Executive Director's Recommendation

PROJECT**Dwight D. Eisenhower Memorial**

Preliminary approval of site and
building plans

Disapprove and provide comments
on preliminary site and building
plans

Figure 5: Current Memorial site plan (April 2014)

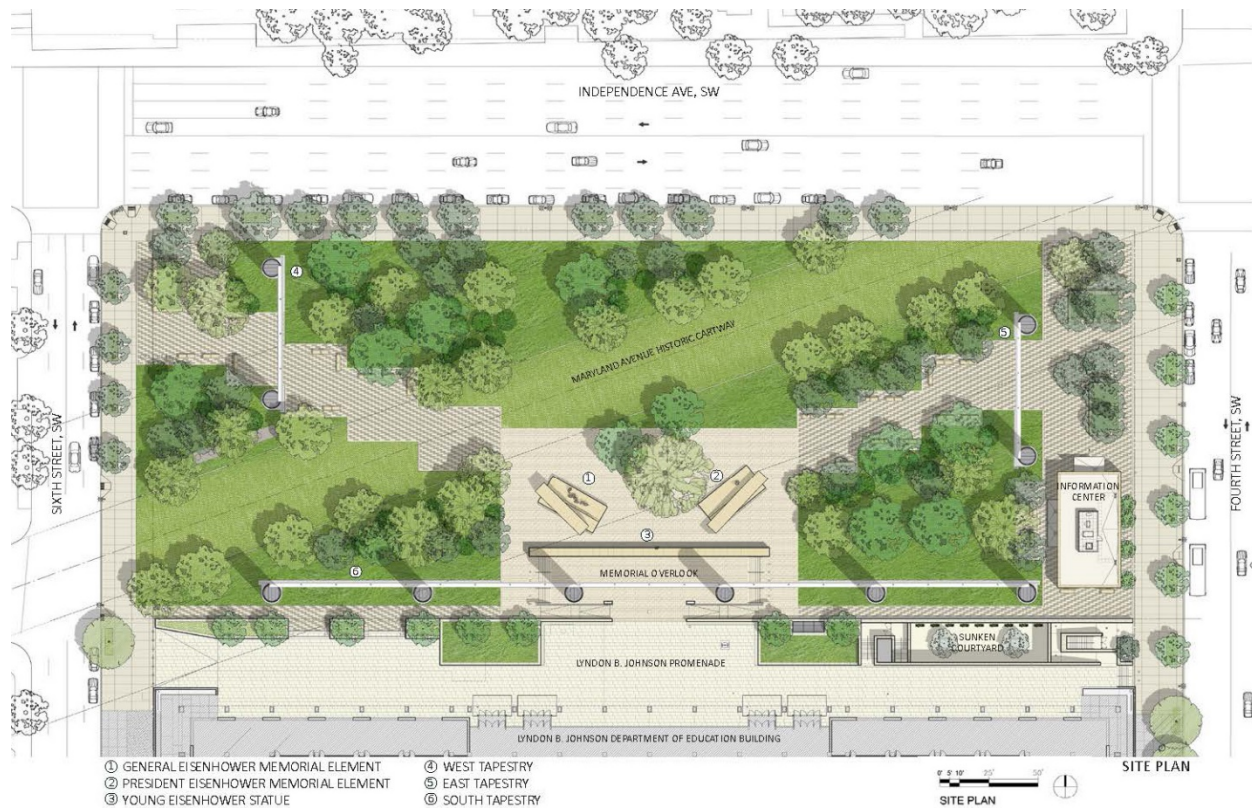
Compared to existing conditions, significant green space will replace existing impervious surface through a diverse landscape plan that proposes a formal and informal arrangement of vegetation. (Figure 5, 18 and 19) In acknowledgement of Maryland Avenue, the design creates a meadow-like promenade that will consist of a groomed lawn. Throughout the rest of the site, a more informal landscape of taller, un-groomed lawn is proposed to evoke the Kansas landscape. The informal landscape will establish a non-uniform arrangement of large canopy trees and smaller, flowering understory trees across the site that will relate to the landscape imagery of the tapestries. The proposed design is approximately 70 percent pervious and will add approximately 1.5 acres of additional landscaped area compared to existing conditions. This significant amount of green space will be a welcomed amenity in an area of the city that is characterized by significant amounts of impervious surface and lacking in useable open space.

Figure 28: February 2011 concept design showing building setback line

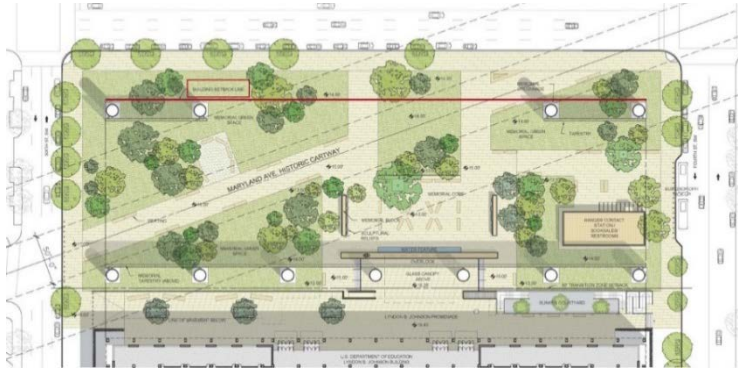
At the concept review stage, the project was inconsistent with these two principles as a result of the two smaller tapestries, which were located parallel to Independence Avenue along a 50-foot setback line that coincided with the adjacent buildings, thereby establishing an extension of the street wall similar to what would occur if a building was constructed on the site. (Figure 28) Staff noted at the time that “rather than striving to reinforce or extend existing street walls, the design principles intend the site to be an opening in the street wall similar to the function of other public squares throughout the city.” In addition, the applicant’s proposed configuration of the tapestries to reflect a proscenium stage setting did not reflect L’Enfant Plan principles and complement the Department of Education building. (Figure 11) Generally, the concept precluded the surrounding buildings’ ability to define the Memorial site, all of which have thematic ties to President Eisenhower, and instead created a precinct within a precinct.

Figure 29: Diagram showing redefined relationship to buildings and 4th and 6th Streets

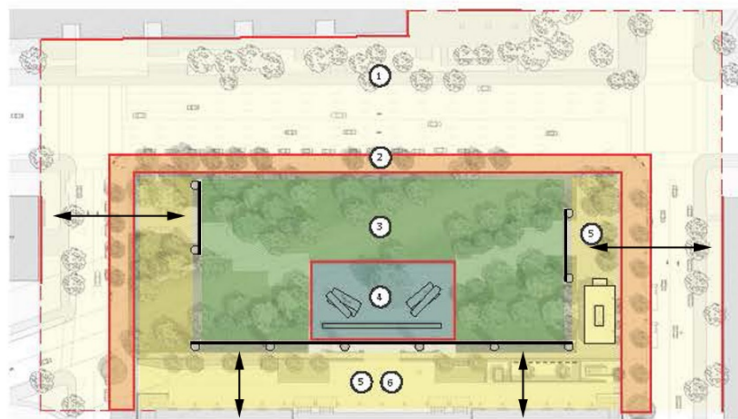
the east and west sides to define the site. (Figures 29) The placement of the east and west tapestries also takes away from the success of the urban park as a unifying element within the precinct. Rather, the spatial relationship is established more between the adjacent buildings and the tapestries as opposed to the Memorial core and the surrounding park. (Figure 30) Furthermore, while the reduction in length of the south tapestry has opened up oblique views of the east and west ends of the LBJ Building, the length of the south tapestry still overshadows the building with regard to views and its ability to help define the Memorial and surrounding park, both physically and thematically, especially when considered in combination with the range of image densities currently planned for the tapestries. (Figure 31)

Figure 33: Diagram showing placement of tapestries in relation to building setback line

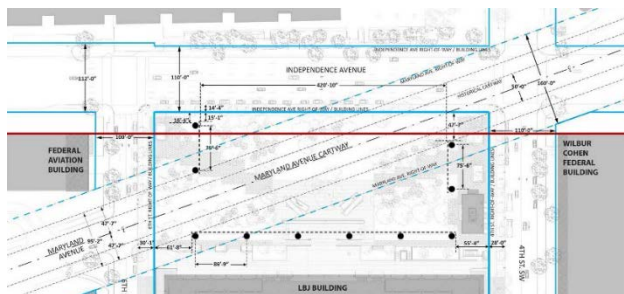
This purpose of this particular principle is to provide guidance with regard to the appropriate placement of Memorial elements on the site while taking into account certain constraints established by existing conditions the surround the site. Similar to other principles that address how the Memorial relates architecturally to the surrounding context, this principle focuses on contextual relationships from the perspective of site planning. With regard to the placement of Memorial elements in relation to the alignment of trees along Maryland Avenue, the current design is successful in that no elements are located within the proposed allee of trees that define the 50-foot cartway. However, regarding Independence Avenue, while the changes to the tapestry configuration address comments from the concept stage, the current design has created a new issue that causes inconsistency with this principle. Specifically, the realignment of the smaller tapestries has resulted in the column at the northwest corner extending beyond the building line established by the adjacent buildings to the east and west (Wilbur Cohen Building and Wilbur Wright Building) creating a visual intrusion into the existing view along Independence Avenue, a primary approach to the Memorial. (Figures 33 & 34)

Figure 40: LBJ Promenade perimeter security barrier line

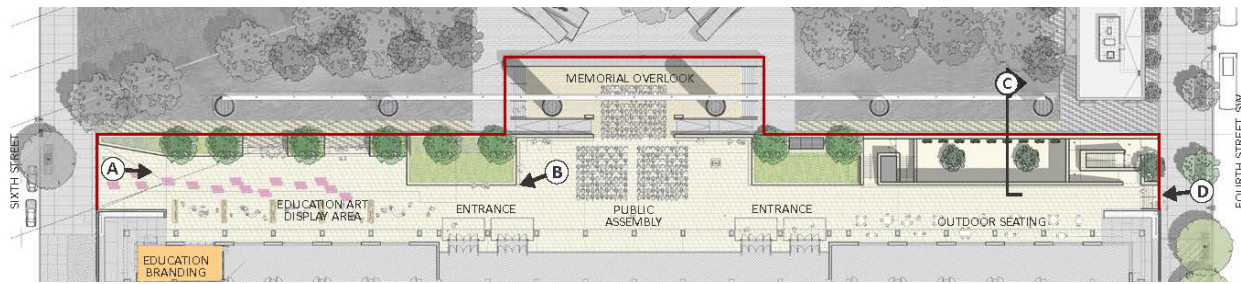
As a result of being slightly higher than the Memorial, much of the security barrier for LBJ Promenade has been integrated into retaining walls along the north side. (Figure 40) Pedestrian access to the Promenade is provided from 4th and 6th Streets and directly from the Memorial via stairways along the west side of the Promenade and at the base of the Memorial overlook. These areas are secured by rows of bollards. According to information provided by the applicant in late-2013, the bollards will be 36-inches high, 12-inch in diameter, and will be clad in stainless steel. As proposed, the bollards will be spaced 5-feet on center resulting in a pedestrian clearance of approximately four feet.

The degree to which the perimeter security is overtly visible has been minimized due to the barrier being mostly integrated into the north retaining wall of the Promenade and Memorial overlook. In addition, given the location and width of the pedestrian access points, the use of bollards seems to be the most appropriate if a security element is absolutely necessary. Staff does, however, have an overarching question as to whether there is an absolute need for the proposed bollards, especially

along the north side of the Promenade, given the elevation of LBJ Promenade, the distance from Independence Avenue, the placement of Memorial elements, and the number trees that will be planted on the site. The combination of these elements seems likely to be effective in protecting the LBJ Building through several layers of security. Specific to the current proposal, and compared to several recent perimeter security projects approved by the Commission, the pedestrian clearance between the bollards seems too narrow and should be evaluated in order to increase this distance to the maximum extent possible. Therefore, staff recommends that the applicant work with the General Services Administration and Department of Education to evaluate the potential for eliminating some or all of the proposed bollards along LBJ Promenade, or address the issue of pedestrian clearance through modifications to the bollard design.
